400 series Palazzo / X73A (UMA/DIS) Schematics

PROJECT : 400 SERIES
Quanta Computer Inc.

Size	Document Number	Rev
	Block Diagram	1A
Date: Friday, July 24, 2015	Sheet 1 of 62

Size Custom	Doc Number	Rev 1A
	EC Nuvoton NPCE576H_1	
Date: Friday, July 24, 2015	Sheet 39 of 82

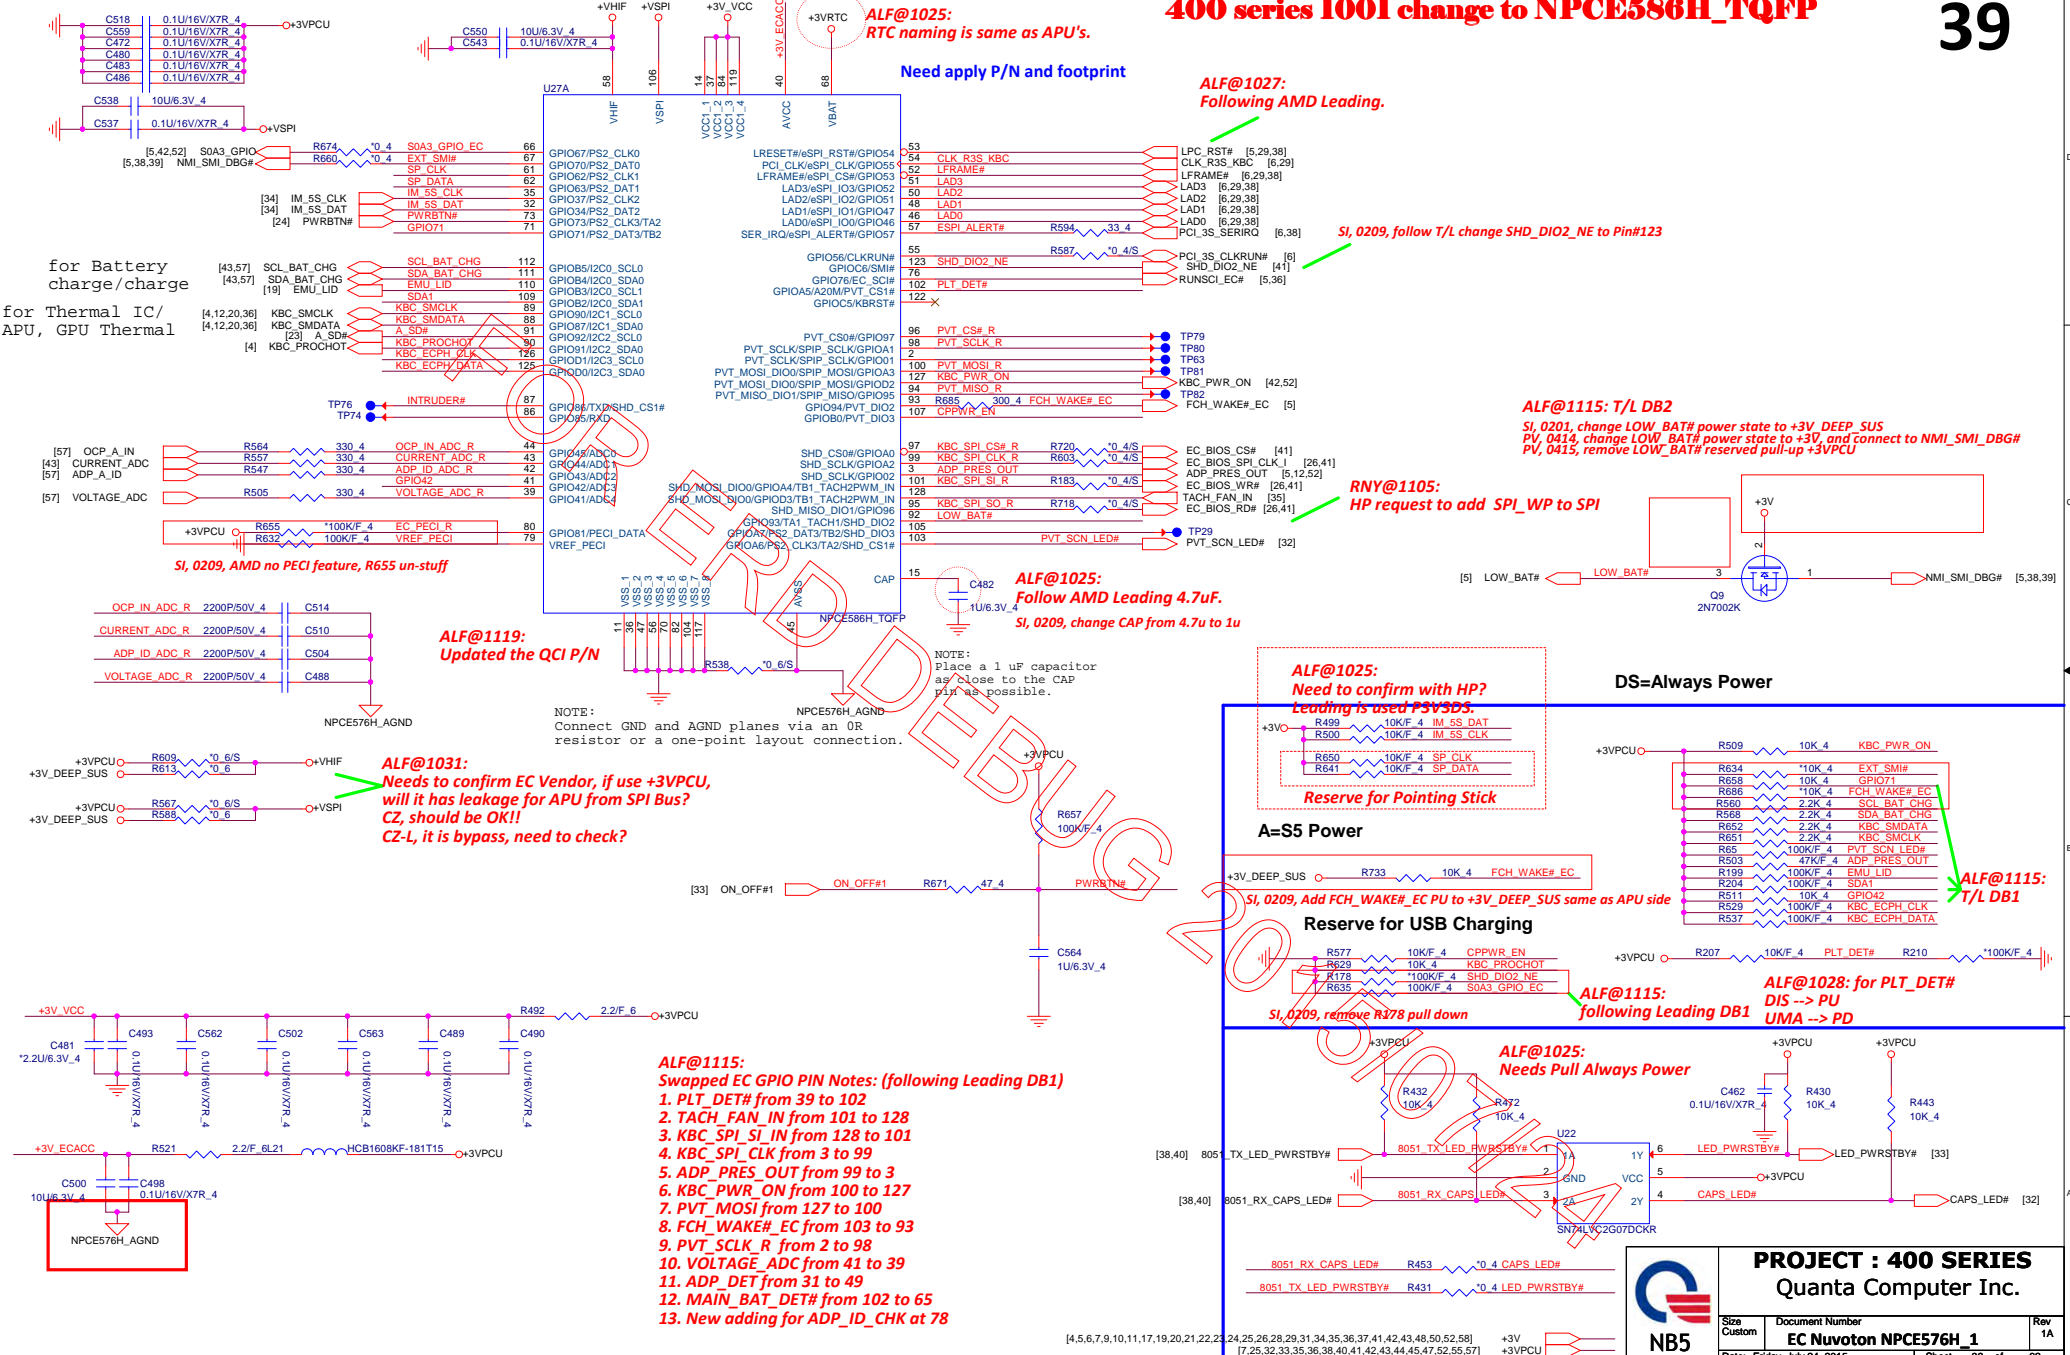
ALF@1028: for PLT_DET#
DIS -> PU
UMA -> PD

- ALF@1115:
Swapped EC GPIO PIN Notes: (following Leading DB1)
1. PLT_DET# from 39 to 102
 2. TACH_FAN_IN from 101 to 128
 3. KBC_SPI_SI_IN from 128 to 101
 4. KBC_SPI_CLK from 3 to 99
 5. ADP_PRESENT from 99 to 3
 6. KBC_PWR_ON from 100 to 127
 7. PVT_MOSI from 127 to 100
 8. FCH_WAKE#_EC from 103 to 93
 9. PVT_SCLK_R from 2 to 98
 10. VOLTAGE_ADC from 41 to 39
 11. ADP_DET from 31 to 49
 12. MAIN_BAT_DET# from 102 to 65
 13. New adding for ADP_ID_CHK at 78

PROJECT : 400 SERIES		Rev 1A
	Quanta Computer Inc.		
	Size Custom Document Number EC Nuvoton NPCE576H_2	Sheet 40 of 82	
Date: Friday, July 24, 2015

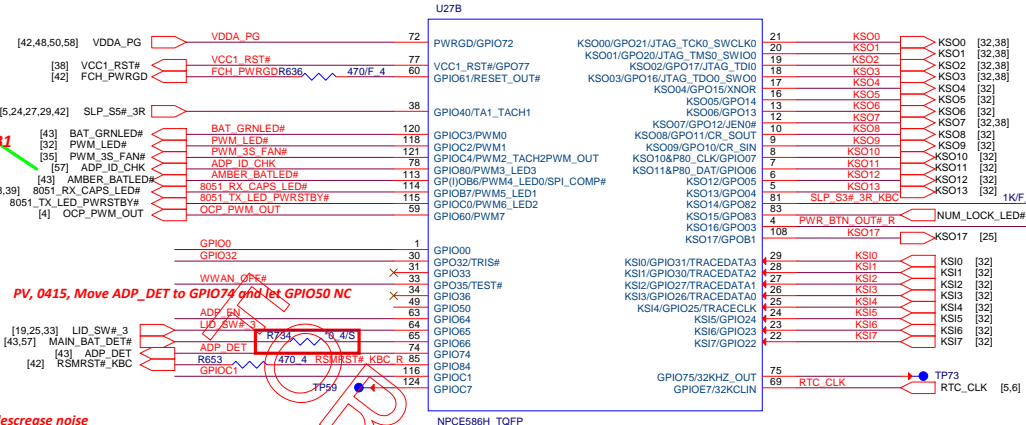
SI, 0204, Add 0.1u to decrease noise
PV, 0416, delete original ADP_DET 0.1uF cap C617

SI, 0201, remove AMBER_LED# PU
SI, 0209, remove 100 K pull-up on KSO7

ALF@1025:
This pin is a strapping pin. AMD platform need to 4.7K PD
Please use a buffer to drive Amber LED.

RNY@1203: Follow leading change SPI strap to PU for 1.8V mode

Size Custom	Document Number Flash(KBC+PCH)	Rev 1A
Date: Friday, July 24, 2015	Sheet 41 of 82

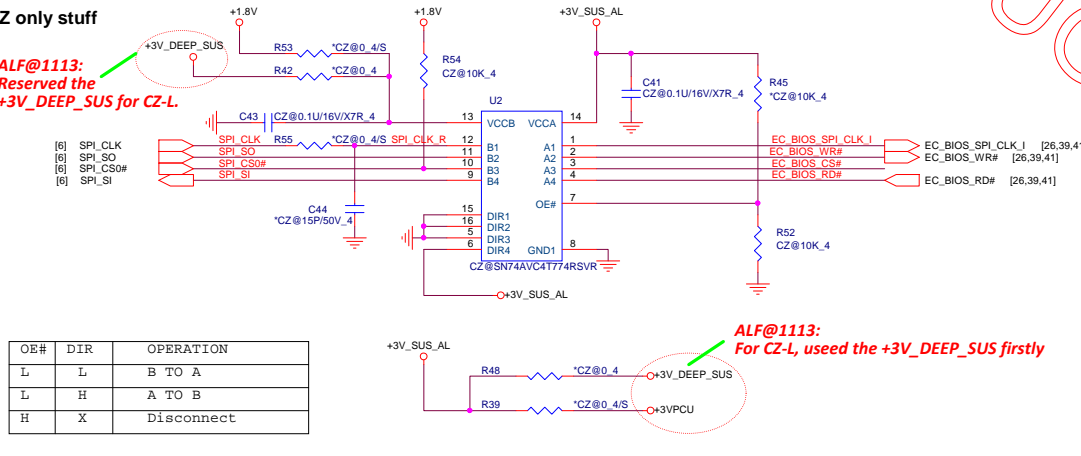
ALF@1031:
Needs to confirm EC Vendor, if use +3VPCU,
will it has leakage for APU from SPI Bus?
CZ, should be OK!!
CZ-L, it is bypass, need to check?

ALF@1113:
Reserved the +3V_DEEP_SUS for CZ-L.

ALF@1113:
For CZ-L, use the +3V_DEEP_SUS firstly

ALF@1113:
1. SPI bus isolation to FCH

ALF@1113:
Confirmed HP, SPI Power Rail same as EC.
